Project	<b>IEEE 802.16 Broadband Wireless Access Working Group</b> < <a href="http://ieee802.org/16">http://ieee802.org/16</a> >	
Title	<b>Revision of Hand-over Mechanism for Mobility Enhancement</b>	
Date Submitted	<b>2004-01-02</b>	
Source(s)	Phillip Barber Broadband Mobile Technologies, Inc. 8302 Sebastian Inlet Frisco, Tx 75035	Voice: +1 (972) 365-6314 Fax: +1 (925) 396-0269 <a href="mailto:pbarber@BroadbandMobileTech.com">[mailto:pbarber@BroadbandMobileTech.com]</a>
Re:	Response to IEEE 802.16e-03_58 (Call for Contributions on IEEE 802.16e/07r5)	
Abstract	Revision of Hand-over Mechanism for Mobility Enhancement	
Purpose	Stimulate discussion on a more completely defined, flexible model and mechanism for facilitating mobility functionality	
Notice	This document has been prepared to assist IEEE 802.16. It is offered as a basis for discussion and is not binding on the contributing individual(s) or organization(s). The material in this document is subject to change in form and content after further study. The contributor(s) reserve(s) the right to add, amend or withdraw material contained herein.

# Revision of Hand-over Mechanism for Mobility Enhancement

## Observations on Curren

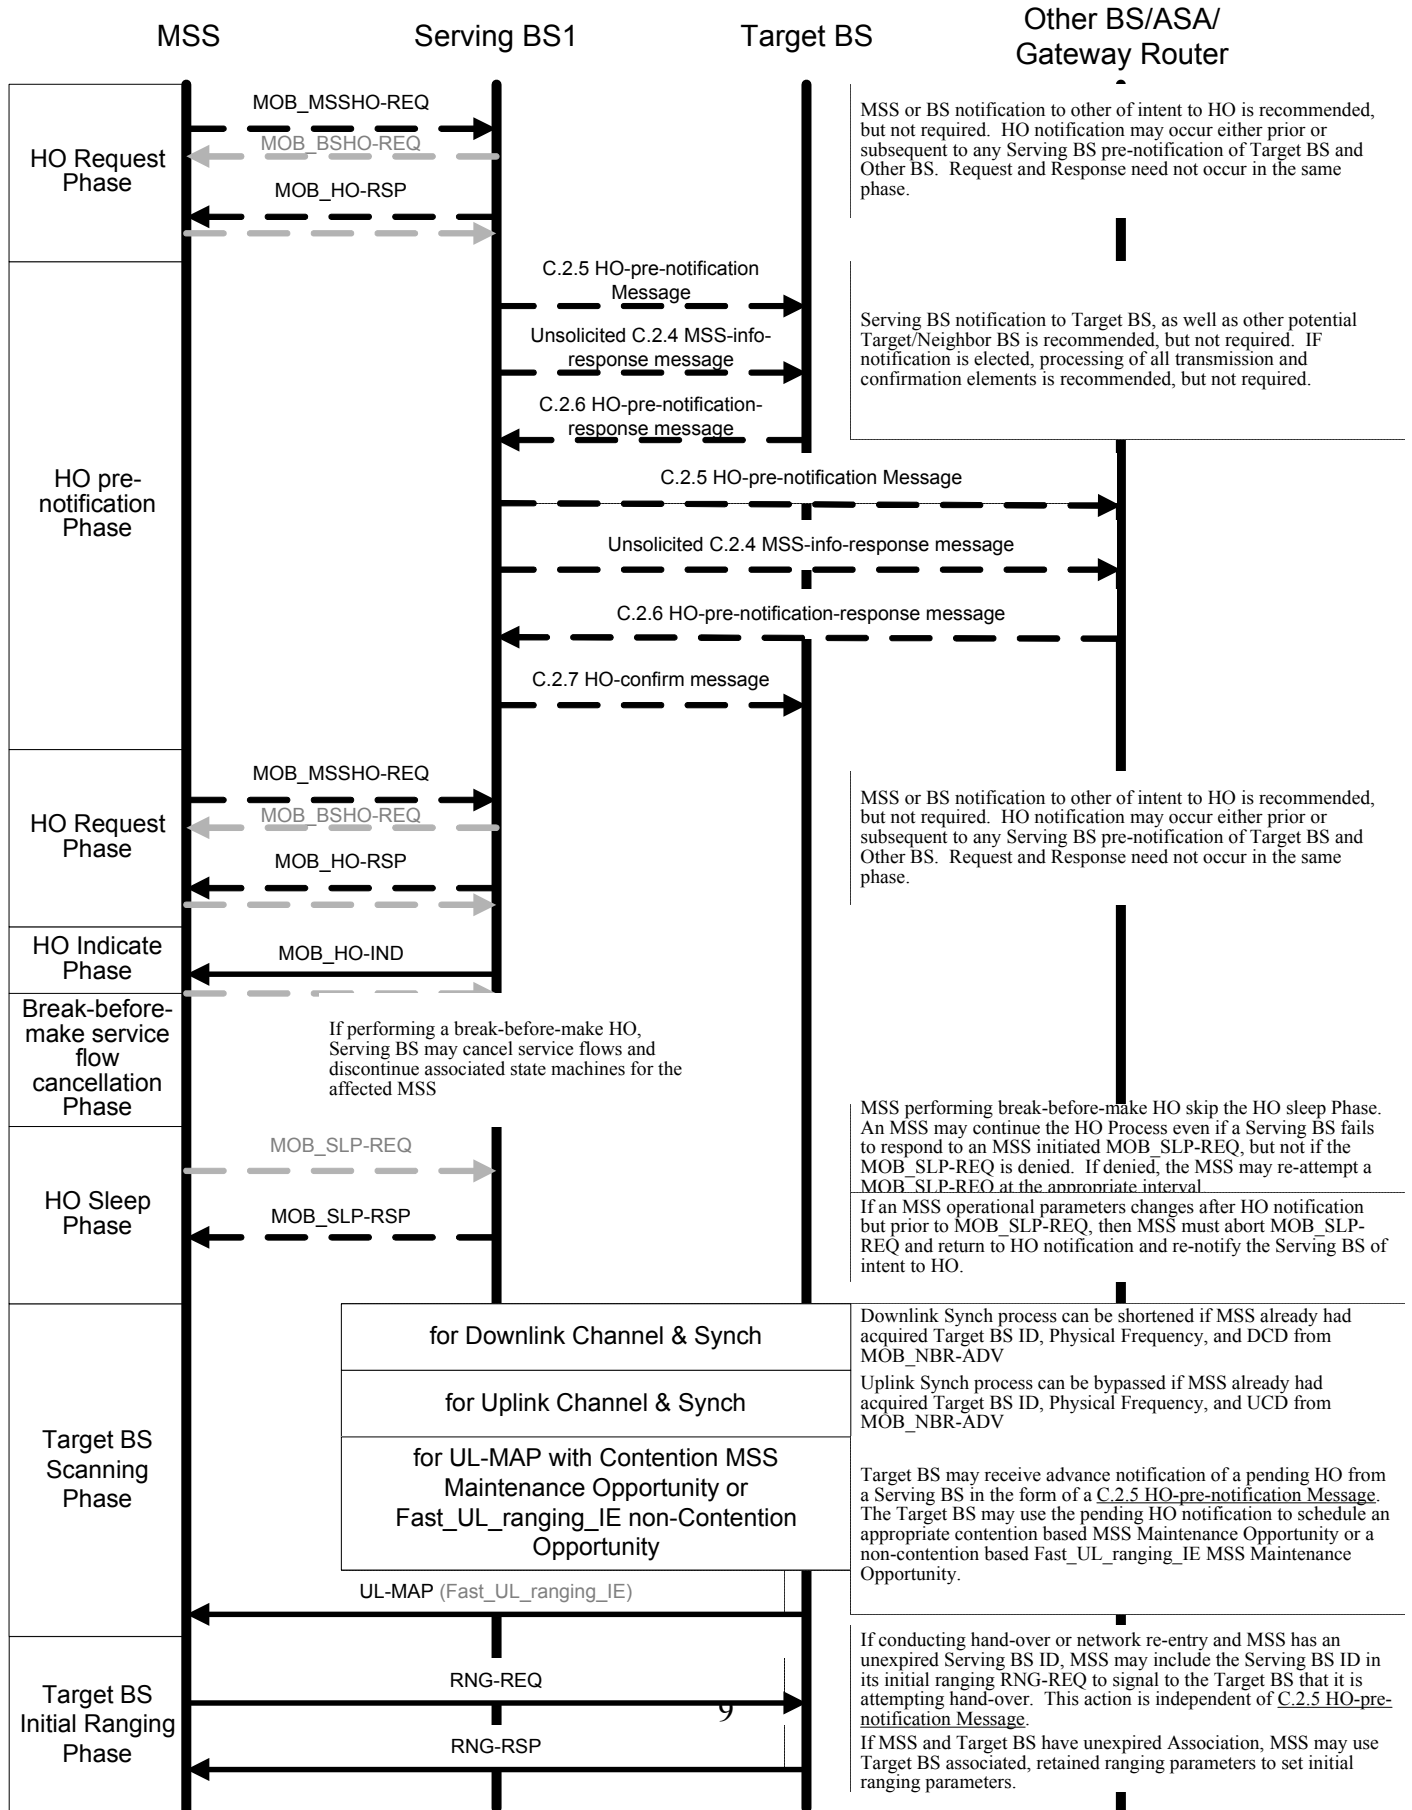
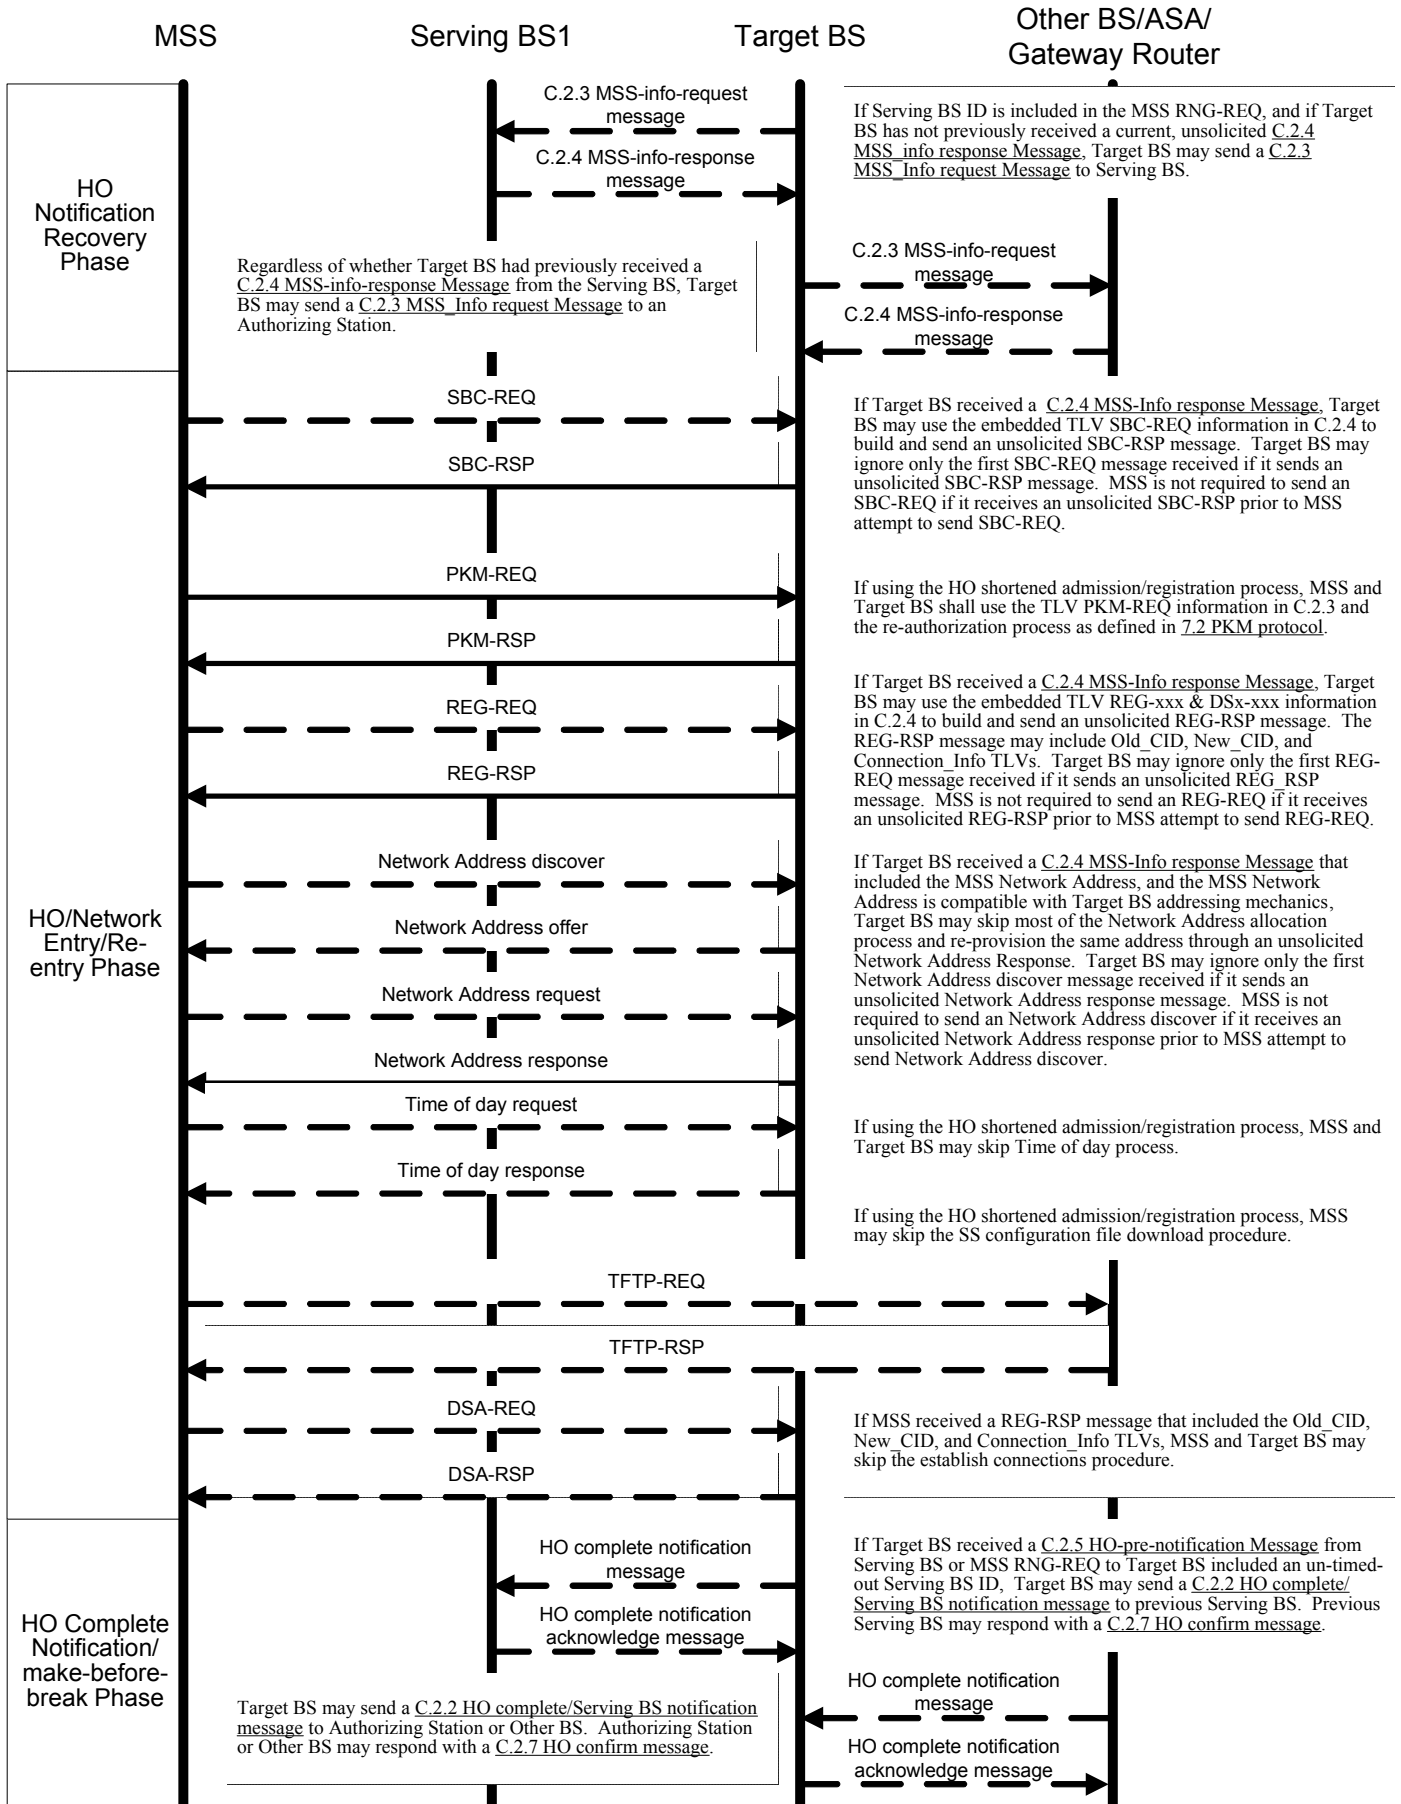
*[In C.2.8 Example of Backbone Network HO procedure, pages 54-56, delete Figure C.2—Example of HO call flow by BS entirely and replace Figure C.1—Example of HO call flow by MS with:]*
